Responses to NRC Letter Dated July 17, 1998
Request for Additional Information on the Reclamation Plan for the White Mesa
Uranium Mill

Source Material License SUA-1358
Docket No. 40-8681

Re: White Mesa Uranium Mill
Response to NRC's Questions Dated July 17, 1998
Site Reclamation Plan

FIGURE 3
 LOGS OF EXPLORATORY BORINGS
 (CHEN & ASSOCIATES)
 WHITE MESA PROJECT

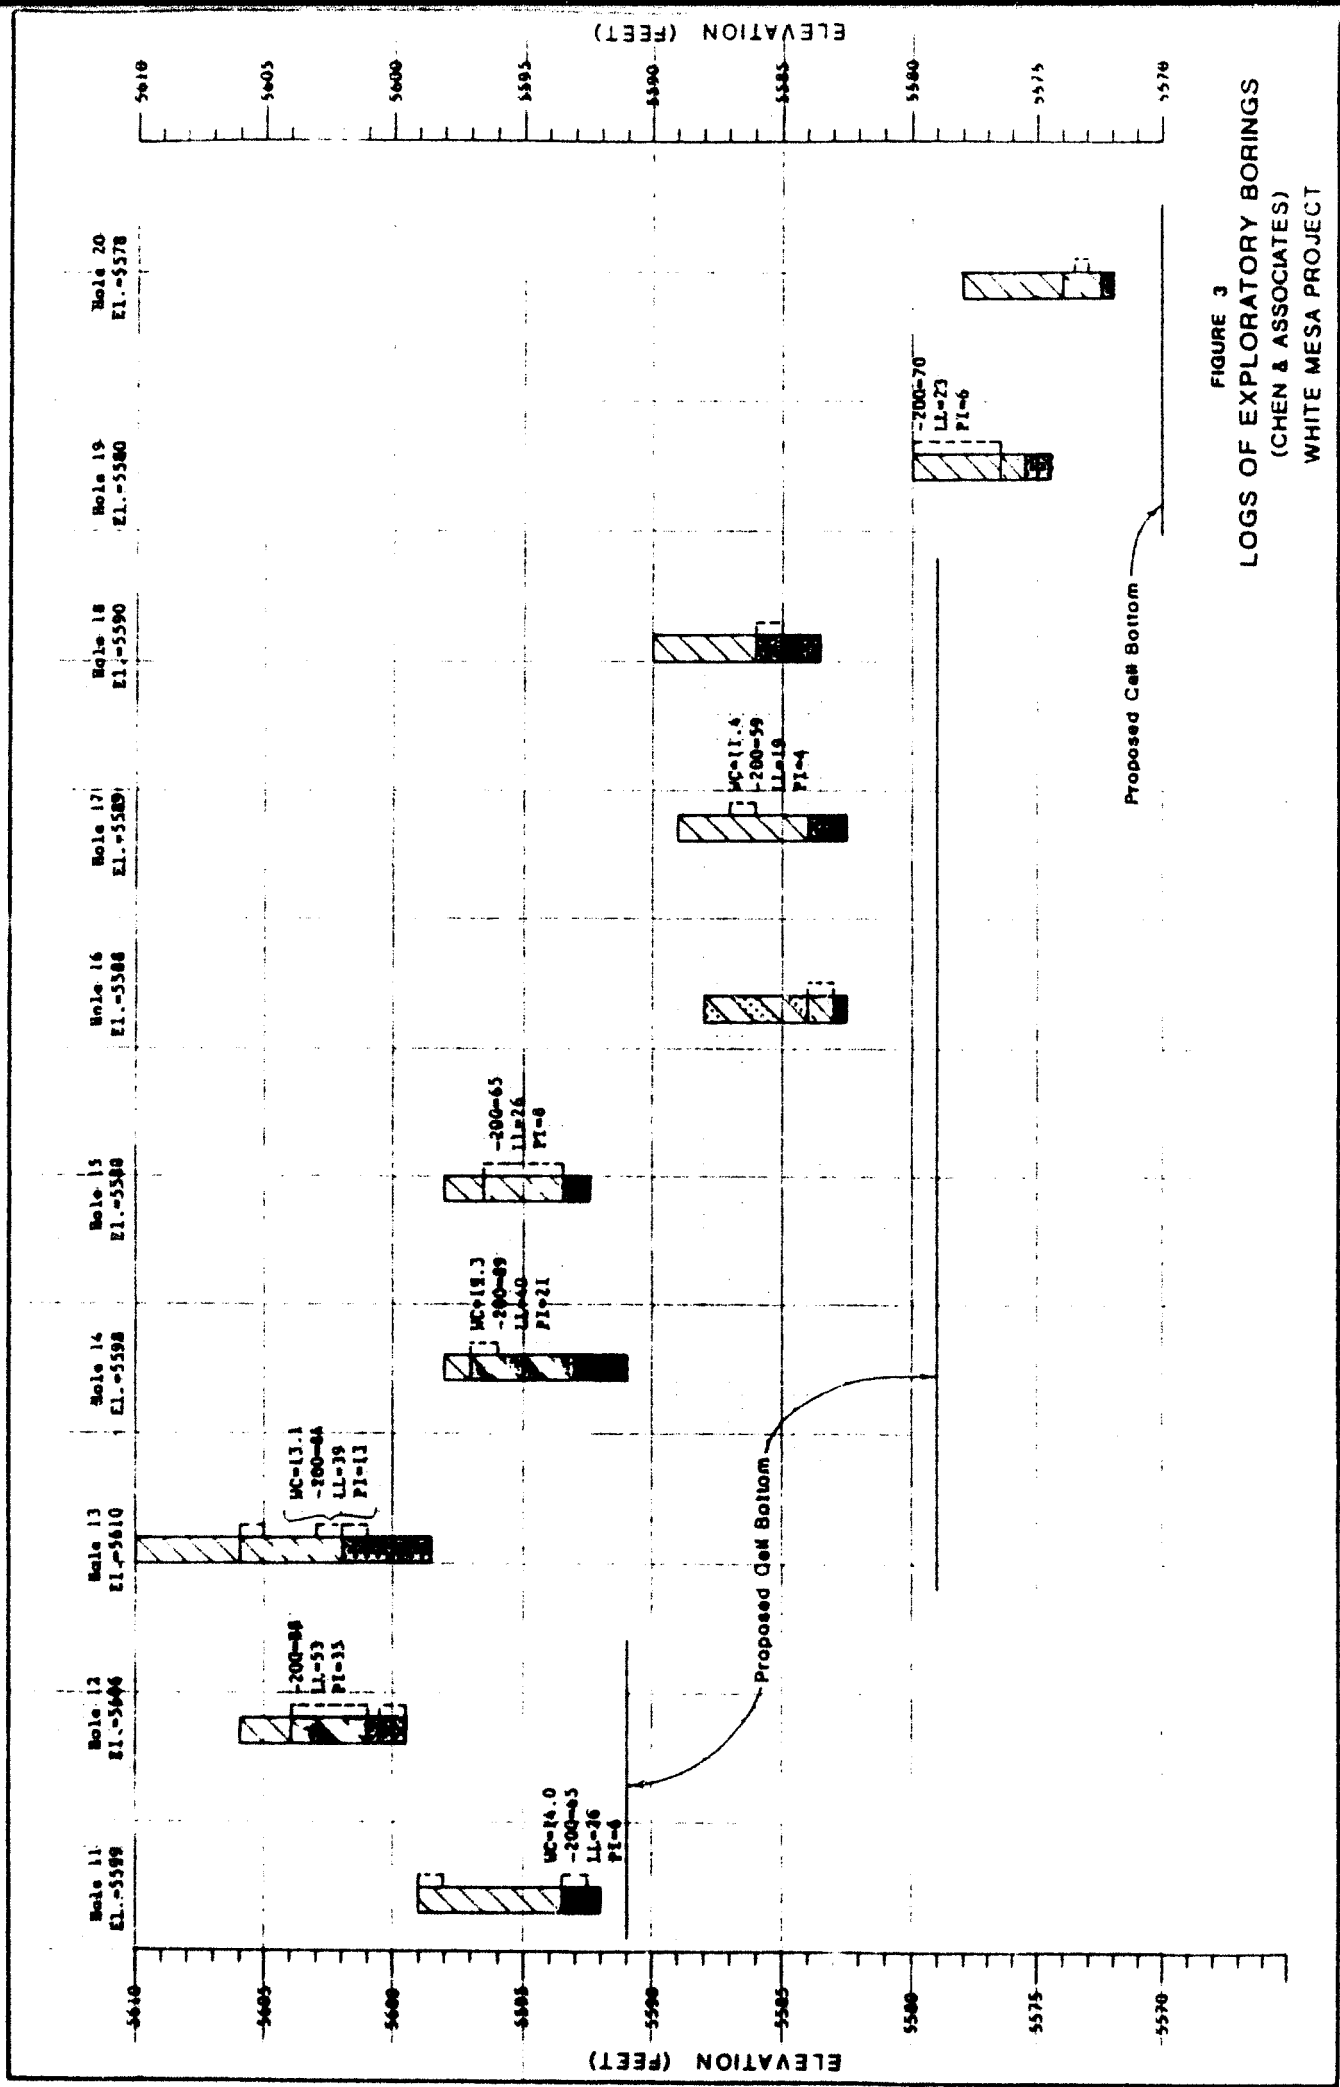
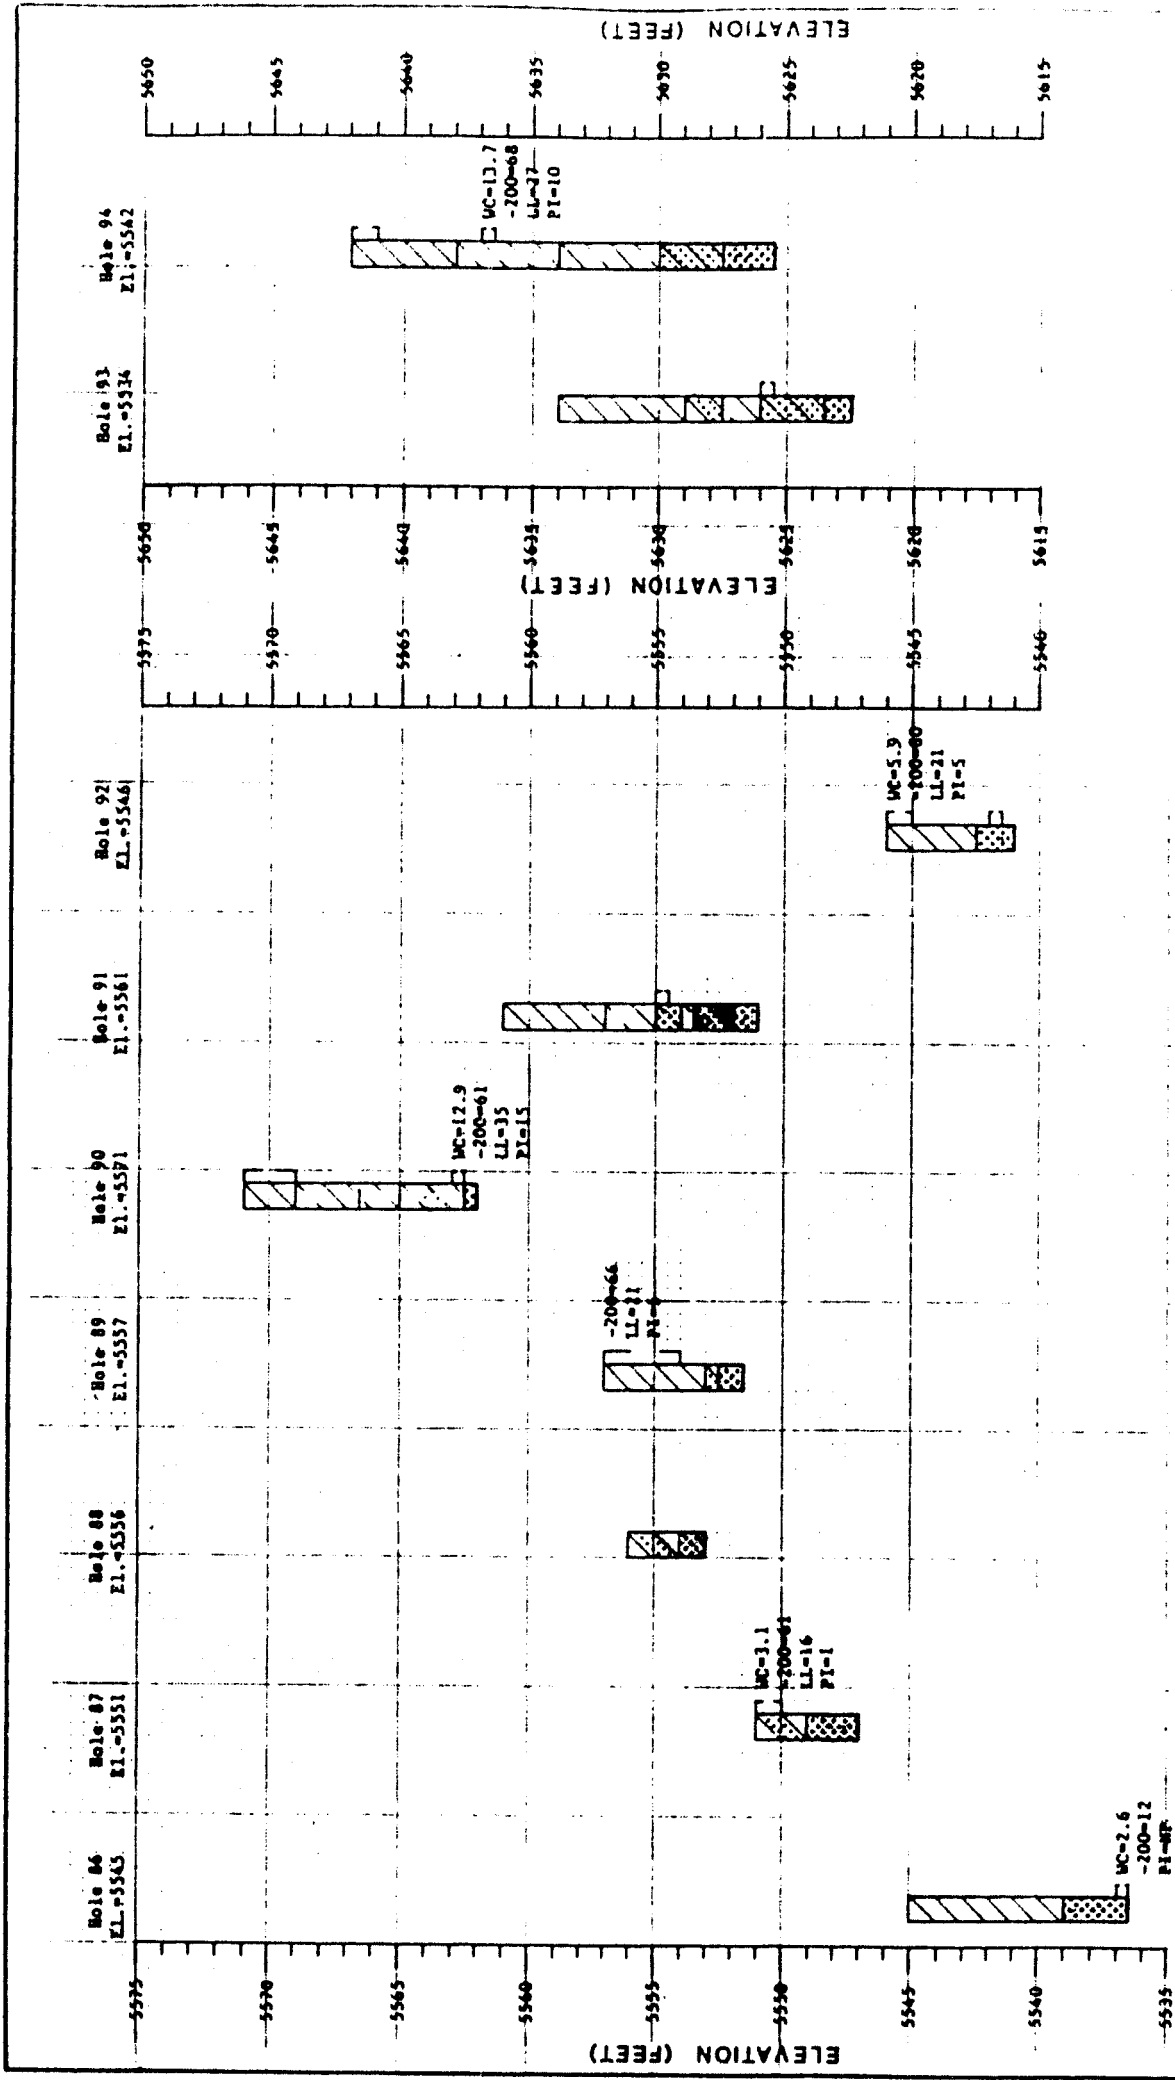
Also, the surface elevation contours given in Figure 3 do not match the borehole logs provided. For example, according to the contours in the figure, the collar elevation of BH-

Concerning the specific example pointed out in this comment, the collar elevation indicated by the map contours (before the cover stockpiles were placed) for the Chen series hole 24 is between 5600 and 5610 which corresponds with the drill log collar elevation of 5609. Drill hole BH-24 (Dames & Moore drill hole 24) has a map collar elevation between 5570 and 5580, with the drill log indicating a collar elevation of 5573. The confusion comes from having two series of drill holes with similar numbering systems and only having a piece of the map without the legend. The attached information should clarify the earlier confusion.

WHITE MESA URANIUM MILL SITE BORING & TEST PIT LOCATIONS	
NO. _____ DATE _____	REVISION - DESCRIPTION _____ _____	DRAWN _____	CHECKED _____
65 2103-1003-11		DATE 02/17/99	SHEET C-1

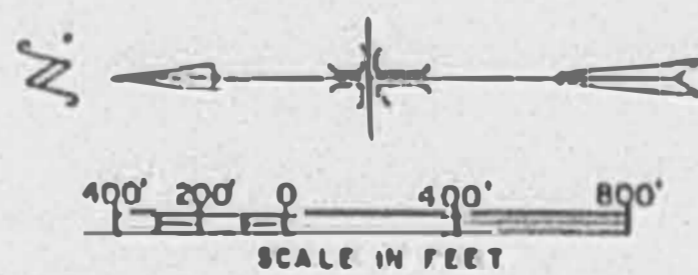
For the above listed samples, IUSA should provide a map showing the sampling locations and the depths at which these samples were acquired.

ATTACHMENT 2
FIGURE 1

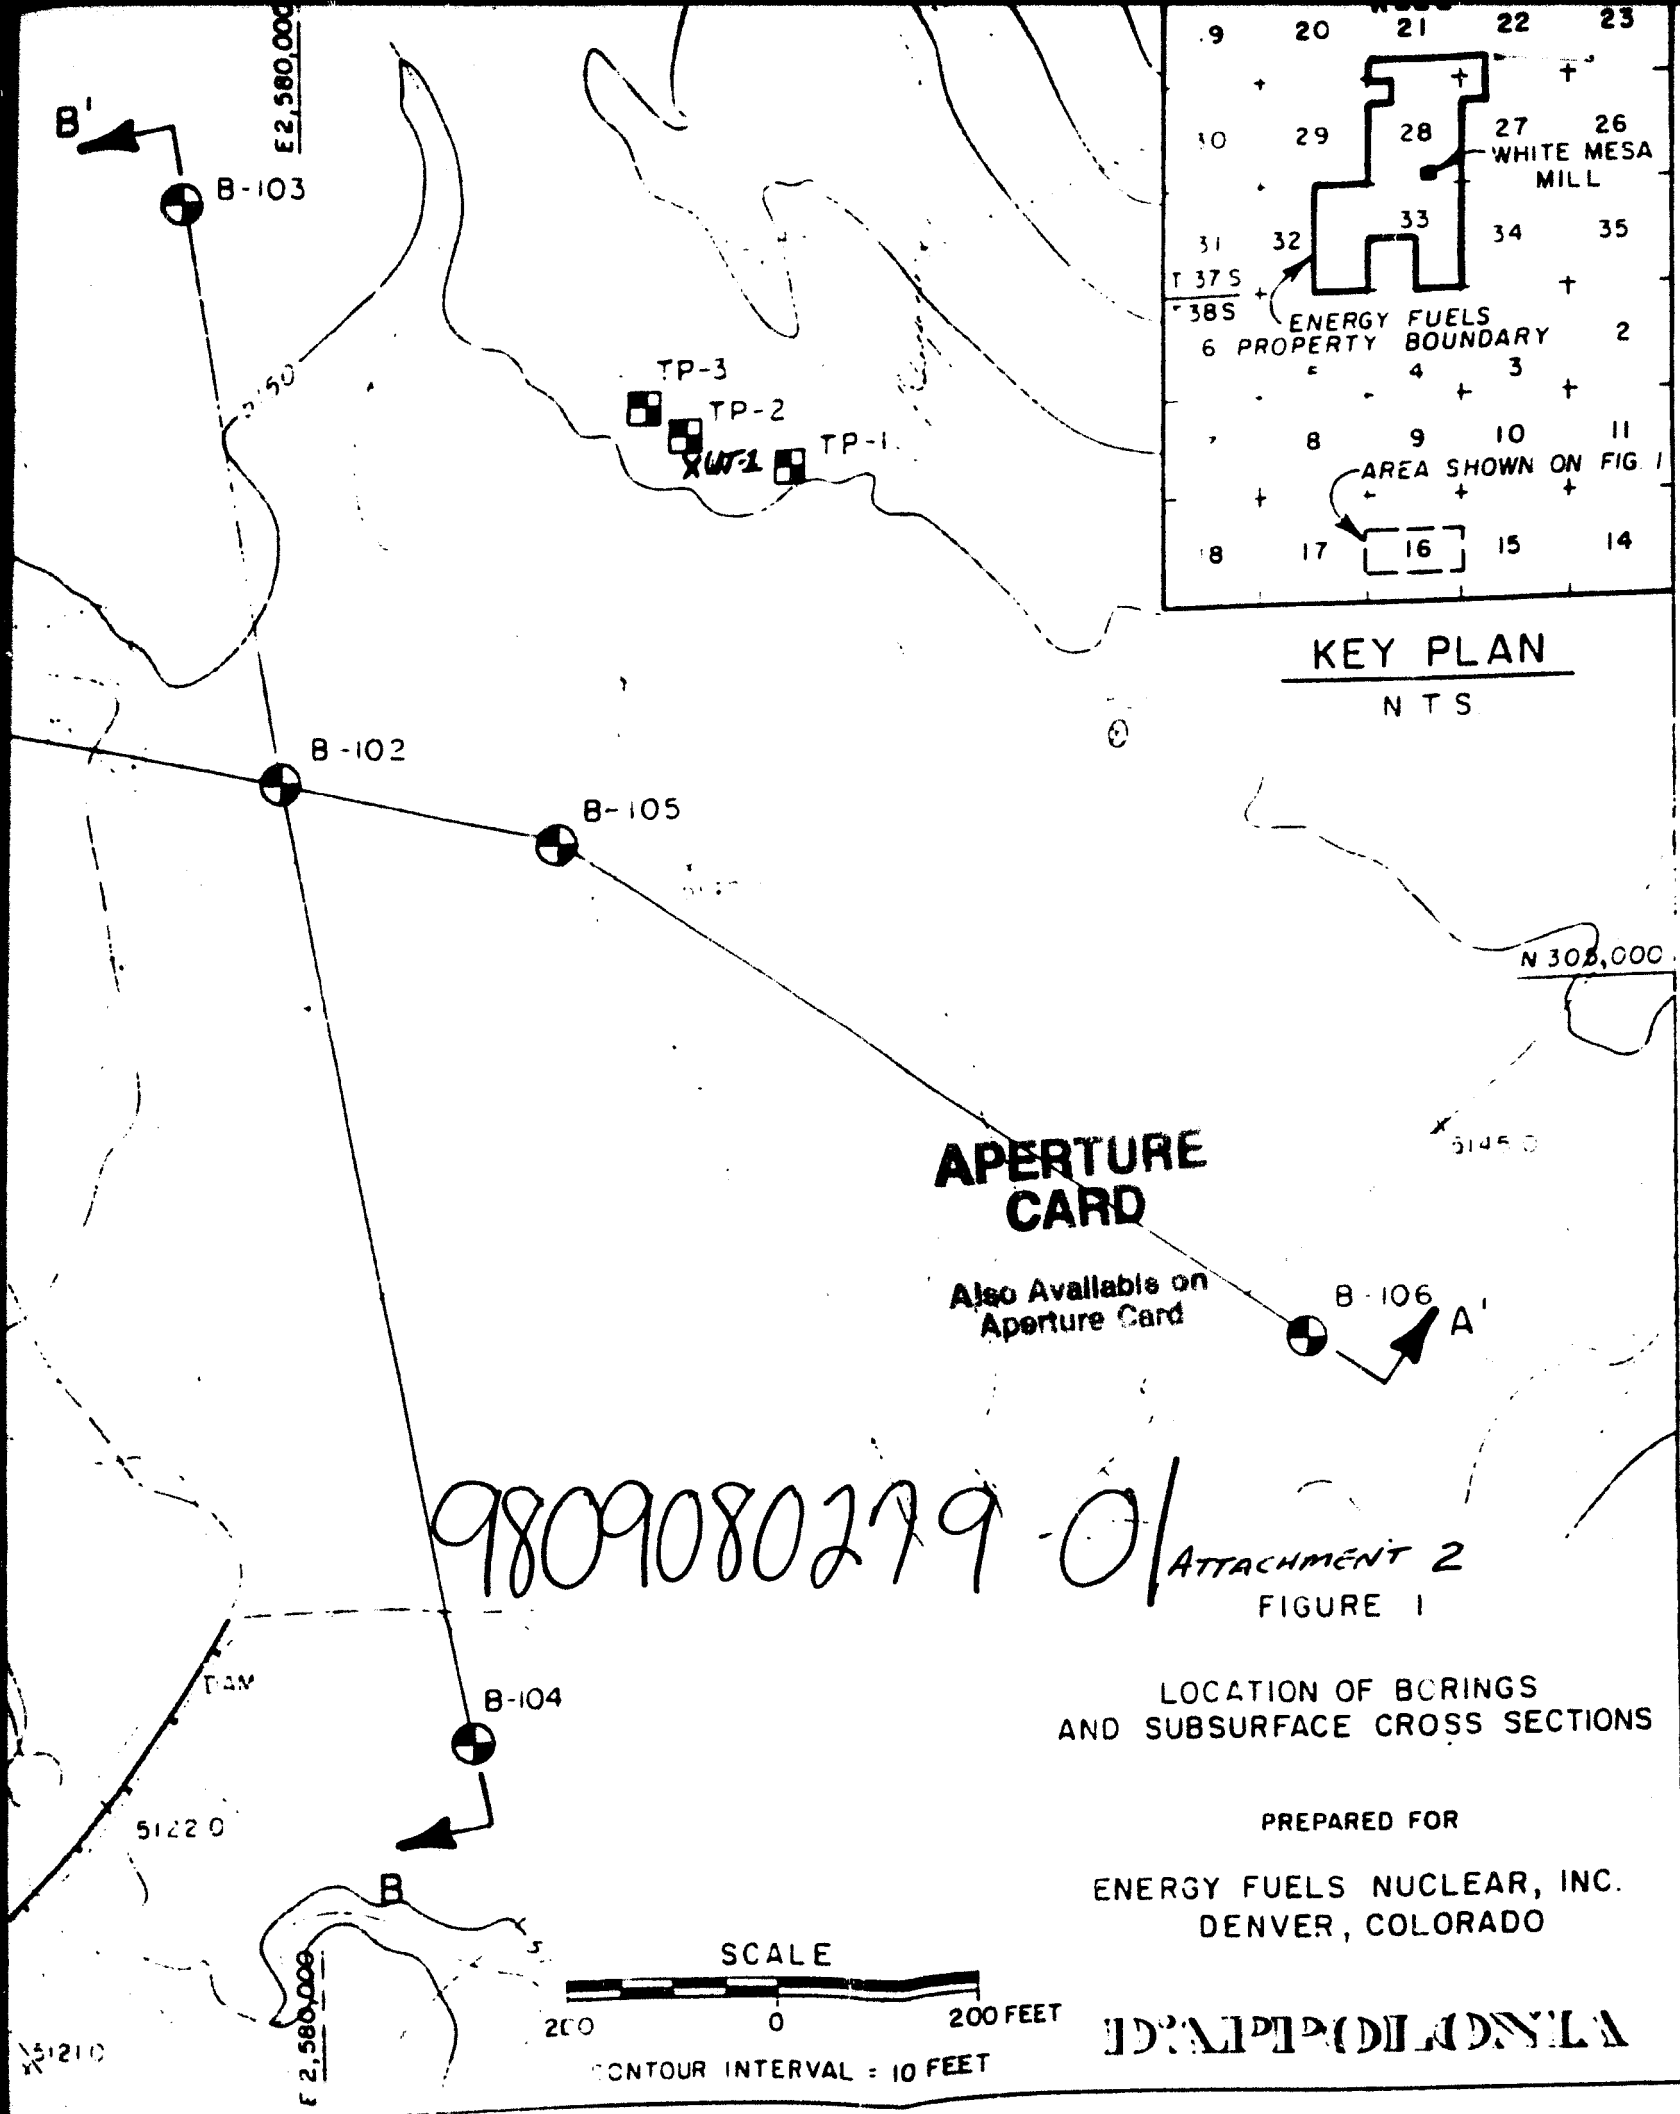
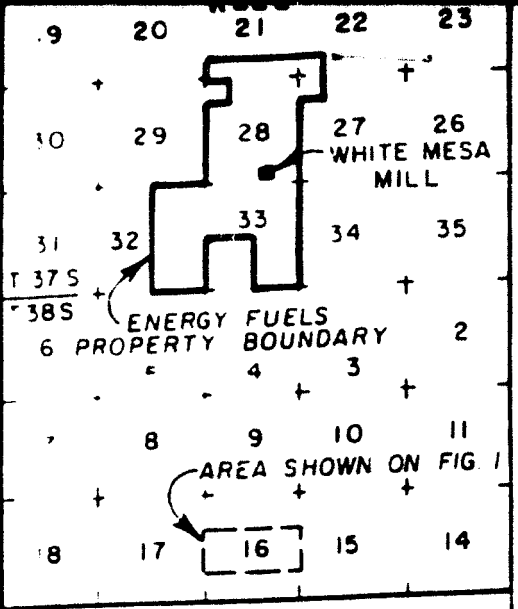
IUSA should provide a map(s) showing the locations of the test holes from which tailings and cover material characterization samples were obtained. The locations to be identified should include those samples described in Appendix A of the reclamation plan and in Attachment A of IUSA's December 16, 1997 response. IUSA also should specify the standards and procedures used to assess the material properties.

laboratory investigation of the borrow area in Section 16 was performed by D'Appolonia in 1982, and the report of that study was submitted to the USNRC most recently on December 16, 1997. The investigation included 6 test borings and 3 test pits located as shown on Figure 1 of that report. Sample UT-1 was taken from the D'Appolonia test pits (TP-2) as shown on Figure 1 - Attachment 2 to this submittal.
